COUNCIL ASSESSMENT REPORT

HUNTER AND CENTRAL COAST REGIONAL PLANNING PANEL

PANEL REFERENCE & DA NUMBER	PPSHCC-336 – 16-2024-587-1
PROPOSAL	Construction of a Residential Flat Building (48 Units), two business premises and one retail premises, associated car parking, landscaping and strata title subdivision
ADDRESS	38 Stockton Street, Nelson Bay LOT: 781 DP: 802108 8A Tomaree Street, Nelson Bay LOT: 782 DP: 802108
APPLICANT	Perception Planning
OWNER	Kinala Pty Ltd
DA LODGEMENT DATE	14/11/2024
APPLICATION TYPE	Local Development Application
REGIONALLY SIGNIFICANT CRITERIA	Section 2.19(1) and Clause 2 of Schedule 6 of <i>State Environmental Planning Policy (Planning Systems) 2021</i> declares the proposal regionally significant development as: the development has an estimated development cost of more than \$30 million.
CIV	\$33,526,091 (excluding GST)
CLAUSE 4.6 REQUESTS	Yes – Clause 7.22 Active Street Frontages
KEY SEPP/LEP	• <i>State Environmental Planning Policy (Biodiversity and Conservation) 2021</i> • <i>State Environmental Planning Policy (Housing) 2021</i> • <i>State Environmental Planning Policy (Planning Systems) 2021</i> • <i>State Environmental Planning Policy (Resilience

Figure 3. Ground floor communal space

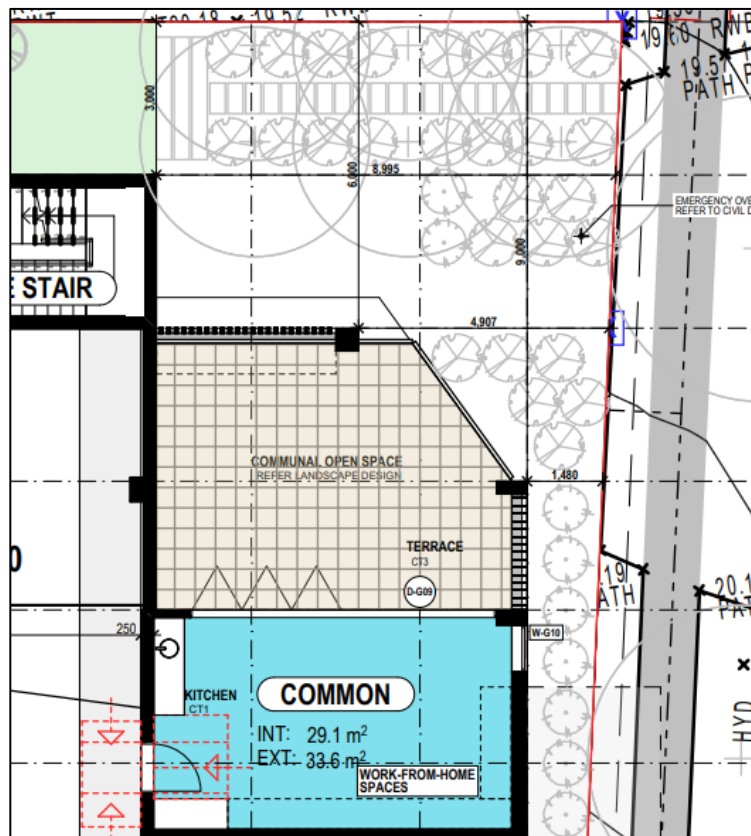
The plans lodged with the DA included two commercial premises and one residential unit on the ground floor fronting Stockton Street. Due to non-compliance with the CI 7.22 and the absence of a CI 4.6 variation request, Council requested the residential unit be removed.

The location of the proposed ground floor unit was in an area slightly raised from street level and therefore that applicant noted it would not be viable to have a business or retail premise in this area of the building. The Port Stephens Design Review Panel therefore recommended that the residential unit be removed and replaced with a communal area which would provide some form of activation to meet the intent of the of the PSLEP clause. The HCCRPP also raised concern with the amenity of the proposed ground floor unit in the initial briefing for the application.

The plans were amended which removed the ground floor residential unit and replaced it with an communal area which includes an indoor room with a kitchenette with the intent for it to be used as a 'work from home' space. This area connects directly to an outdoor terrace. A CI 4.6 variation request was also lodged for the non-compliance with this Clause. The proposed variation is supported by Council as the proposal meets in the objective of the clause by providing two business premises that front Stockton Street, which will attract pedestrian traffic.

Figure 4. Communal open space

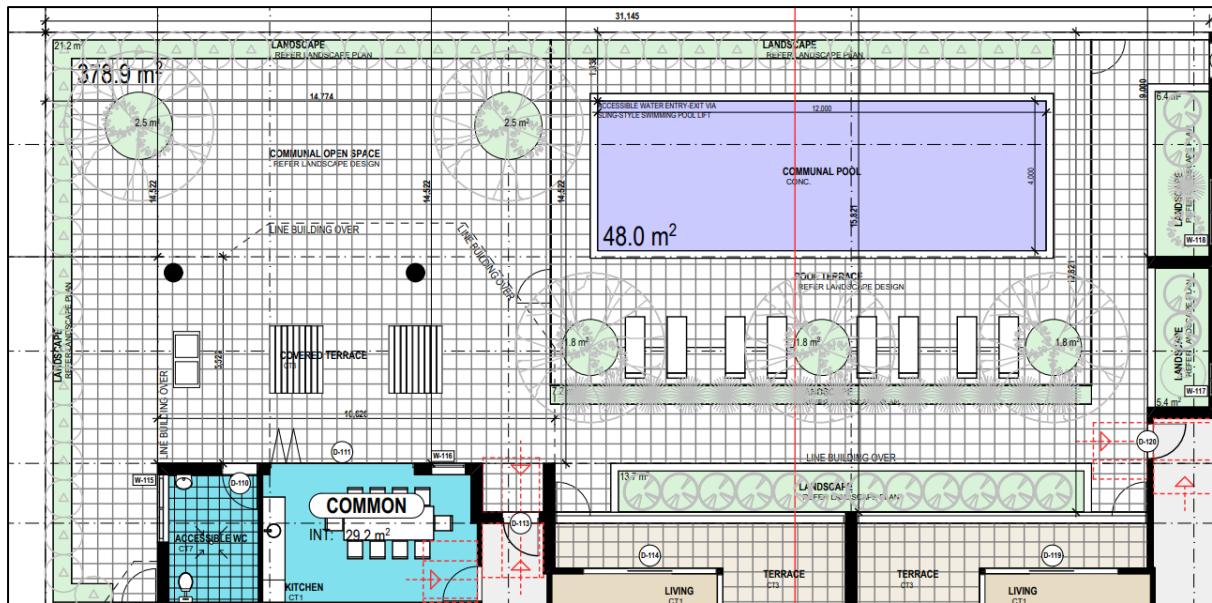
Following lodgement of the DA, the application was referred to DRP on 12 December 2024. The DRP recognised that improvements had been made to the design since the pre-lodgement review however, remained of the opinion that the proposal required further redevelopment, particularly the bulk and scale of the building, the design of the ground floor and its interface with the street, communal spaces, landscape design and unit design. The applicant has since provided amended plans following advice from the DRP, making the following amendments:

- Increased size of the communal open space located on the podium level to be compliant with the ADG. The layout of the communal open space was also amended to reduce to the pool size and provide an area large enough for residents to entertain larger groups of people, as recommended by the DRP.

Figure 8. Waste storage rooms located on the ground floor

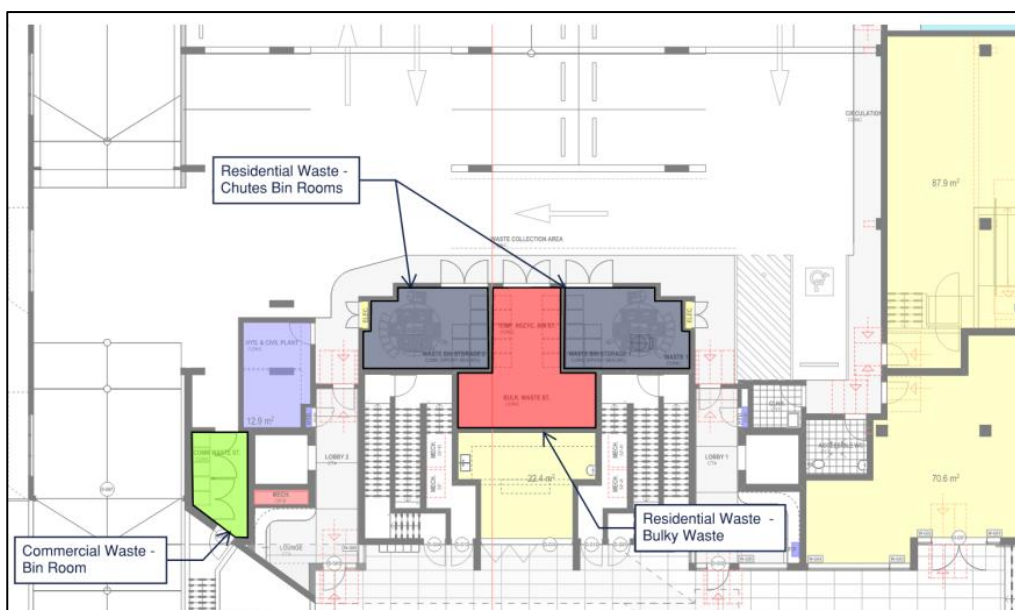
The HCCRPP raised waste servicing as a key consideration in the initial briefing for this application. Waste storage areas are provided on the ground floor of the development with separate storage rooms provided for the residential units and the commercial premises. A Waste Management Plan (WMP) was prepared for the proposal by WGA which considers operational waste, finding the waste storage areas suitable for the proposed development.

Based on the above, the WMP identified that one collection per week will be required for both recycling and general waste. The WMP confirmed that the waste rooms provided on the ground floor are suitable to store the required waste bins.
